CITY OF PORTLAND

BUILDING PERMIT

Job ID: 2011-11-2659-ALTR

Jonathan Rioux - Re: Re: 17 Coyle

DATE: 1.19.2012
DRAWN BY: BB
A-1.1

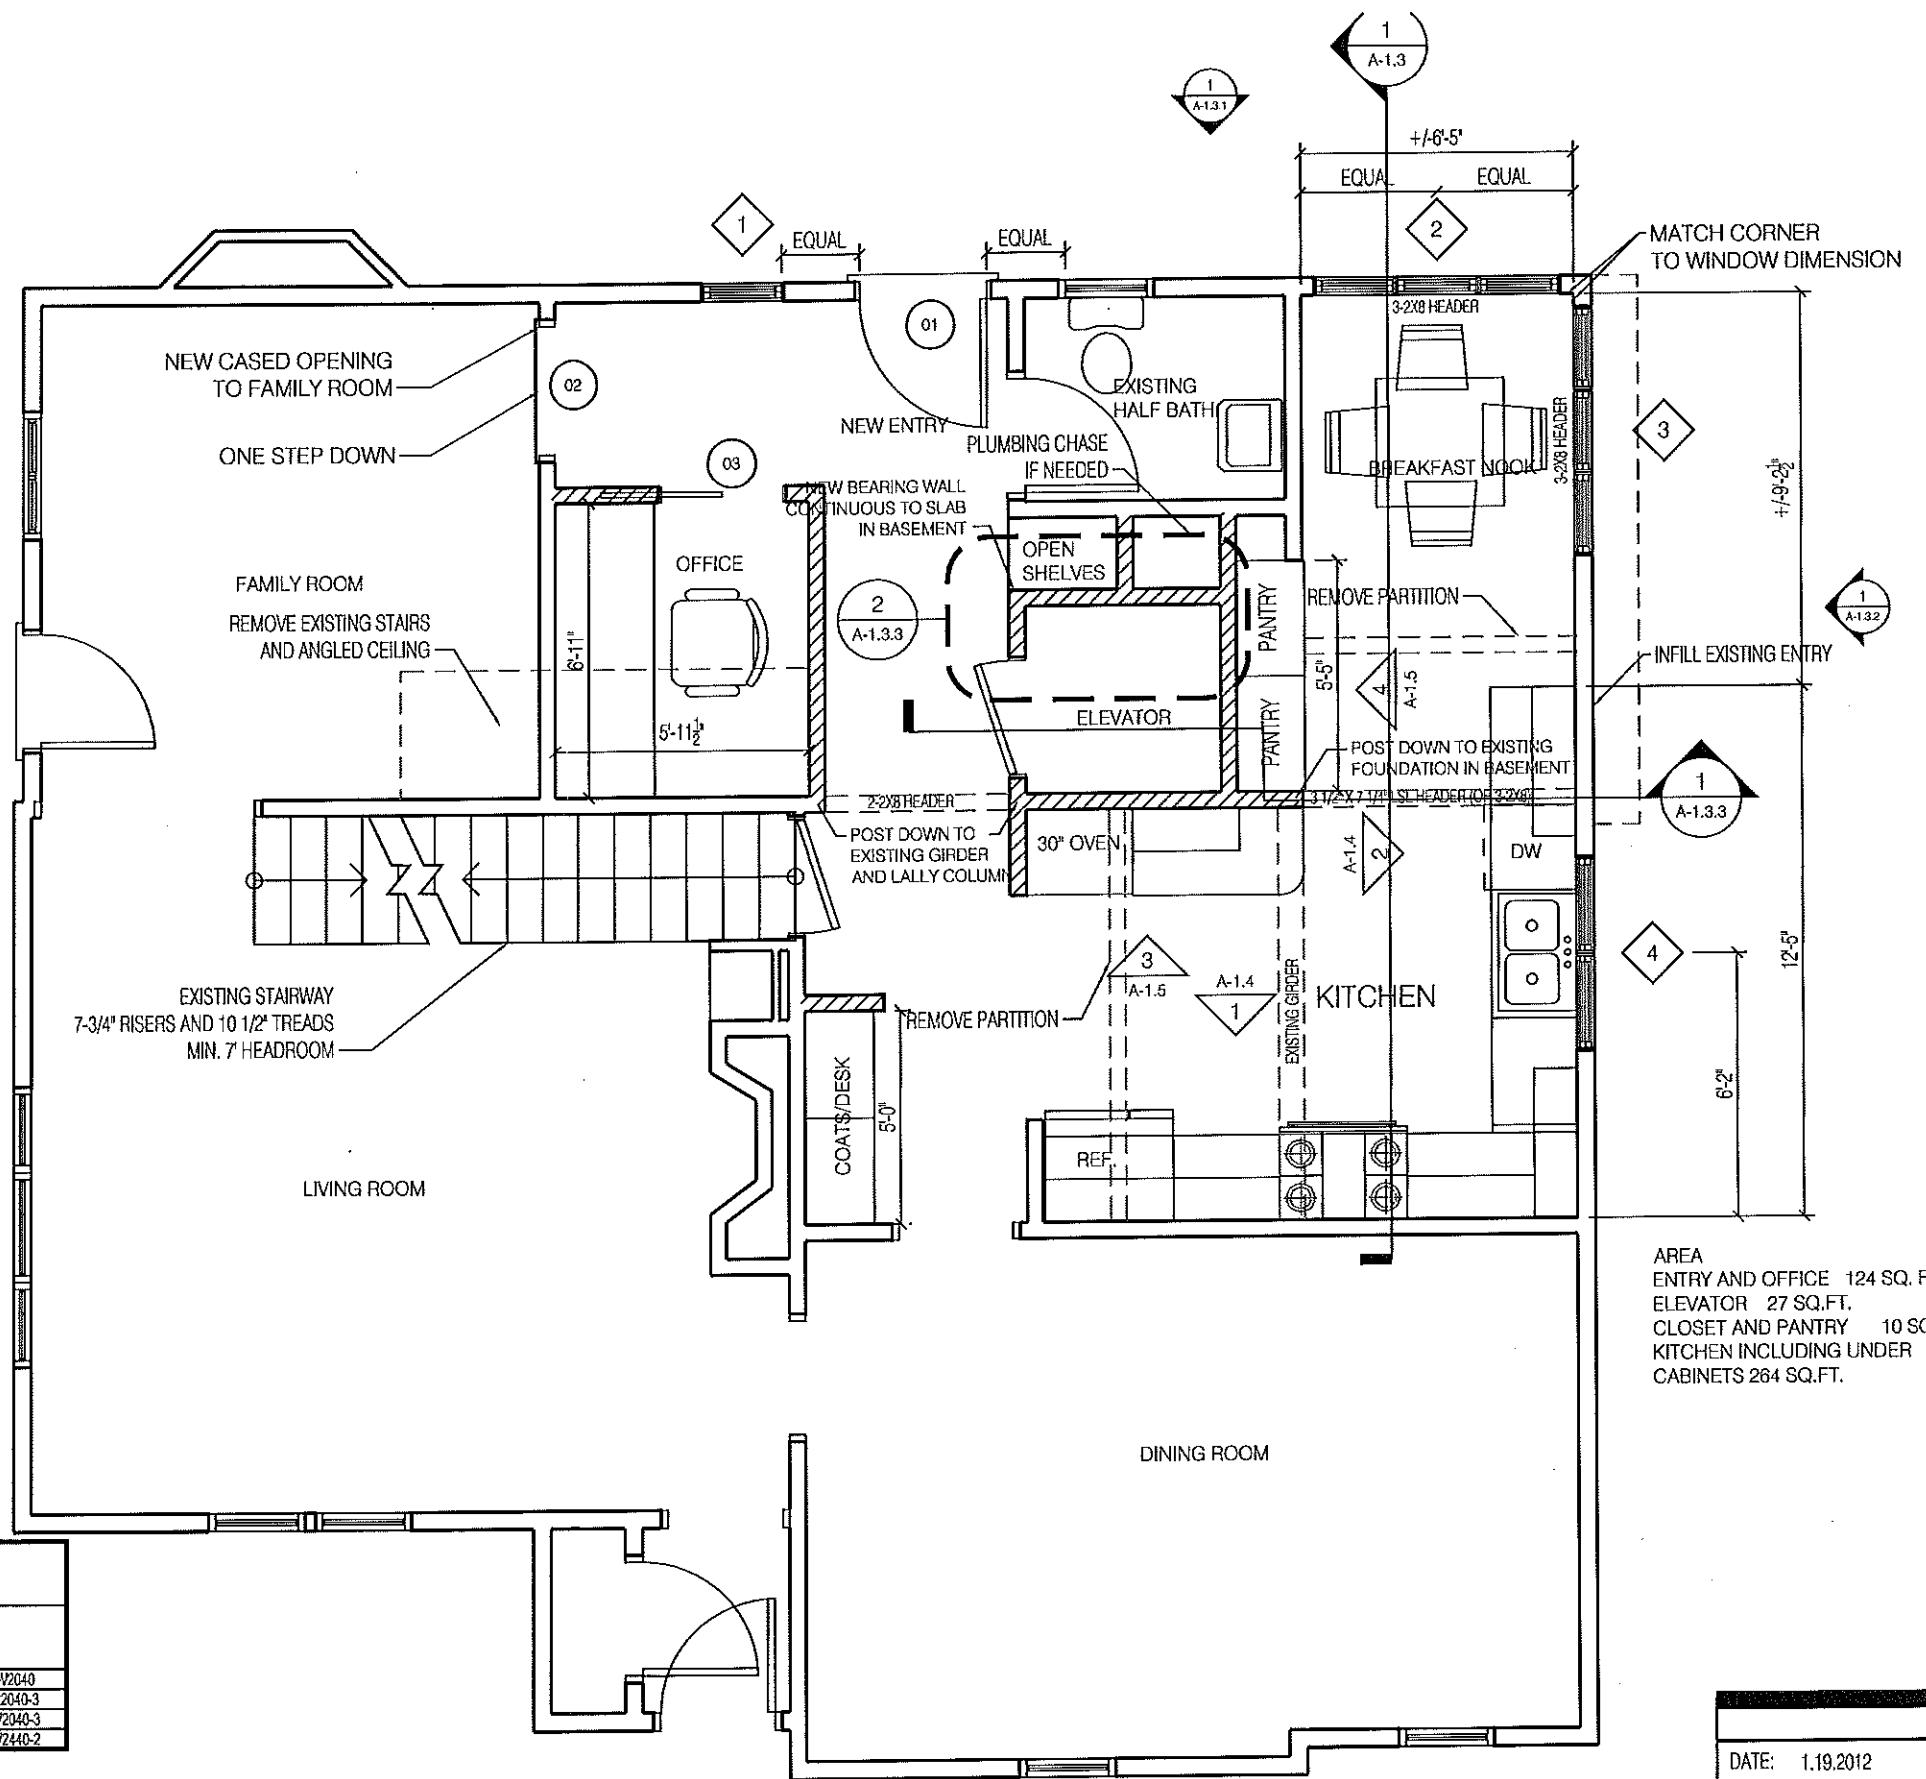
3. Window sills in locations more than 72 inches from finished grade shall be a minimum of 24 inches above the finished floor of the room, unless a window fall prevention devices is installed in accordance with section R612.3. **Note Drawing "A-1.1" Window Schedule for first floor only; See the condition(s) below for any change (additions or enlargement) to the existing bedrooms.**

1. Cross section of all new Girders & how they are posted down to foundation.
2. Cross section/ framing detail for elevator shaft.
3. Finish Ceiling Height in the Bathroom
4. Section "A-1.1" indicated that the existing stairs was removed, if a new stairwell is created/

alter a cross-section (Rise, Run, Headroom, and Handrails) must be submitted for review.

I drafted the section that illustrates what was already noted on the plan. Specifically, how the elevator shaft walls bear down to the basement slab or existing basement girder. The joists that are cut for the shaft bear on these walls. The only new girder bears on a post (also shown in the section) that bears to an existing interior foundation wall. I added a detail of the additional framing in the elevator wall where the rail is attached. This detail is per manufacturer's specification.

Finished bathroom ceiling is dimensioned at 7'-6". This is the same ceiling as the existing bedroom currently in that space.

We are not creating a new stair. We removed an existing steep secondary stair. The remaining existing stair is conforming.
